PRODUCT INFORMATION BULLETIN

Date: November 22, 2021
Number: 112221
Division: Genie®
Product Family: Residential Opener Accessories
Product Series: Battery Backup
To: All Genie Professional Line Wholesalers, Dealers, and Installers
Re: New Part Numbers for 140V Battery Backup Accessory

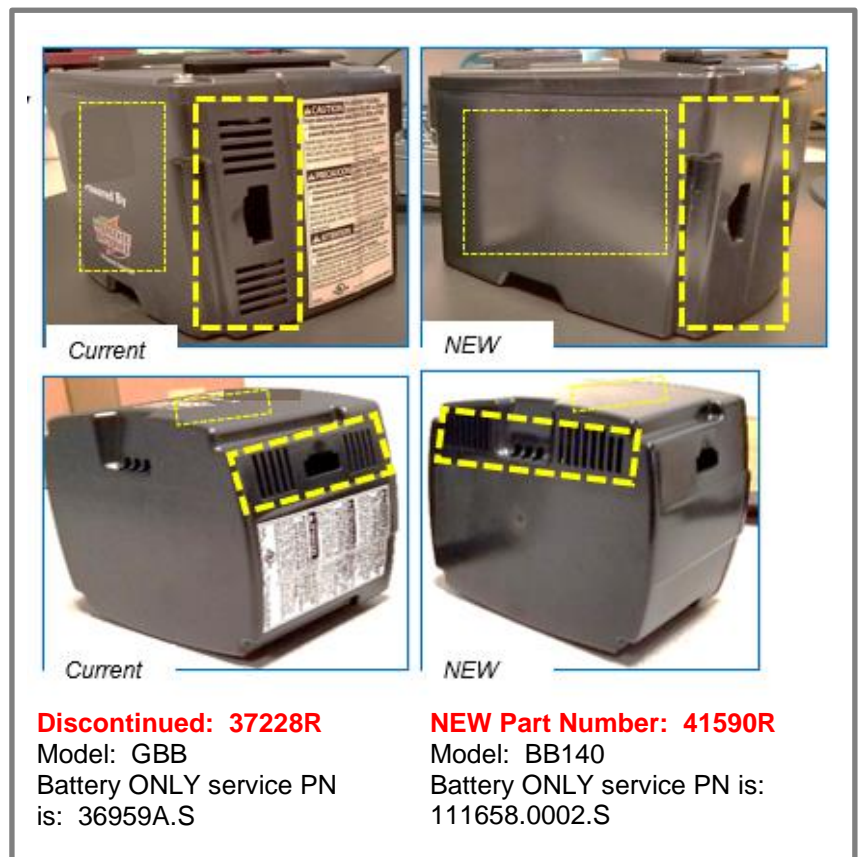
Please note, effective immediately, part number 37228R for the 140V battery backup accessory has been obsoleted. Please use part number 41590R in its place.

To allow for the consolidation of inventory and supply chain flexibility, we have moved all the battery backups to the same replacement battery service part number and removed all branding from the front of the case and external packaging.

- The vents that were previously located on the side of the unit are now on the bottom.
- There are is no branding on the accessory (this includes the shipping carton as well).

Replacement battery differences: The previous 140V battery backup accessory part number 37228R uses battery replacement service part number 36959A.S. The new battery backup accessory part number 41590R will use 111658.0002.S.
